UNITED STATES ENVIRONMENTAL PROTECTION AGENCY

Re: Information Request for NPDES Permit Re-issuance, NPDES Permit No: NH0001473

The New England Regional office of the United States Environmental Protection Agency (EPA or Agency) is developing a draft National Pollutant Discharge Elimination System (NPDES) Permit (No. NH0001473) for Public Service of New Hampshire's (PSNH or the Company) Schiller Station electrical generating facility in Portsmouth, New Hampshire (Schiller Station).

Figure 1: Approximate thermistor locations

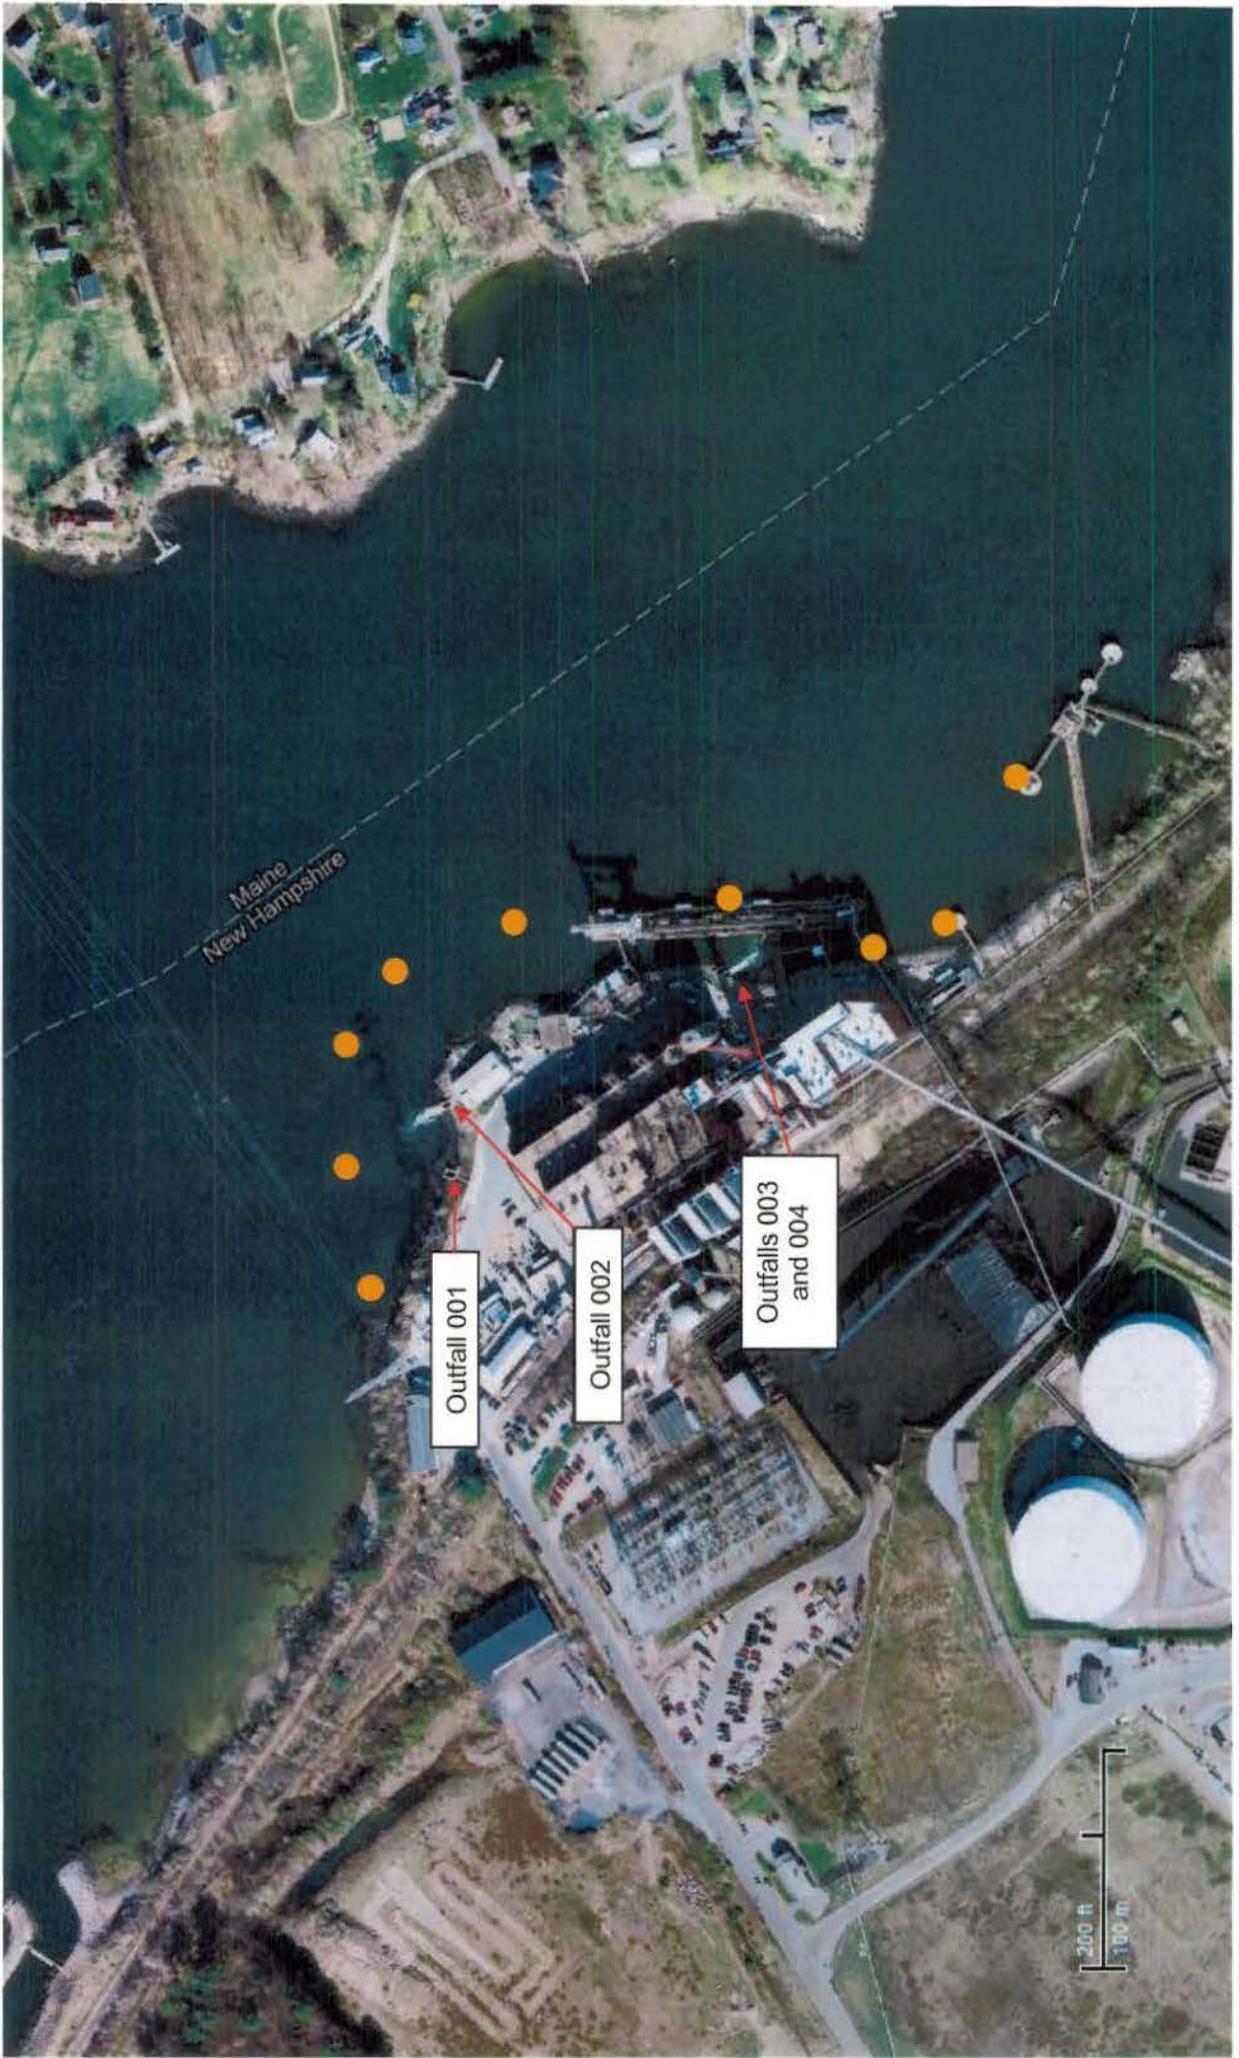
Deploy thermistors at the approximate locations shown on the attached Figures 1 through 4 and deploy thermistors in location(s) to collect ambient Piscataqua River temperature. Please identify monitoring location(s) to collect the ambient Piscataqua River temperature. The ambient monitoring location(s) must be outside of the effects of the thermal plume(s) and will be used to determine background river temperature. Therefore, ambient temperatures must be recorded at locations upstream and downstream of Schiller's discharge. Ambient temperature readings may be taken near the surface.

For water depths greater than twenty (20) feet, use three (3) thermistors per location (one approximately six (6) inches below the water surface, one approximately one (1) foot above the river floor, and one approximately midway between the other two thermistors). For water depths less than twenty (20) feet, use two (2) thermistors per location (one approximately six (6) inches below the water surface, and one approximately one (1) foot above the river floor).
